DOCKET ITEM #11

Rezoning #2014-0007

Development Special Use Permit #2014-0012

4800 Fillmore Avenue – Goodwin House

Tower 203 Turning Specifications

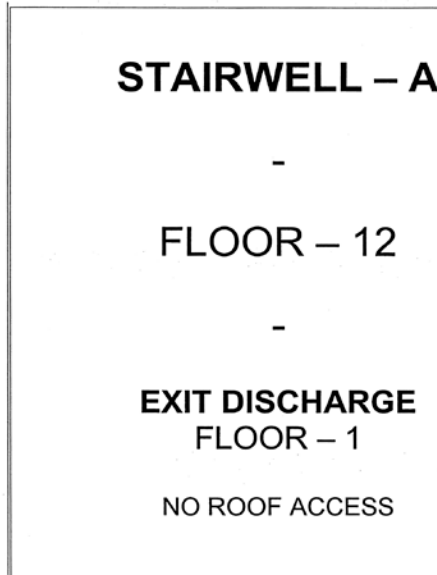
Applicant has proposed additional life safety and fire protection enhancements to overcome lack of fire department access. The turning movement has been improved

and in conjunction with the enhancements will be acceptable. Overhang protruding into drive isle is no longer a problem.
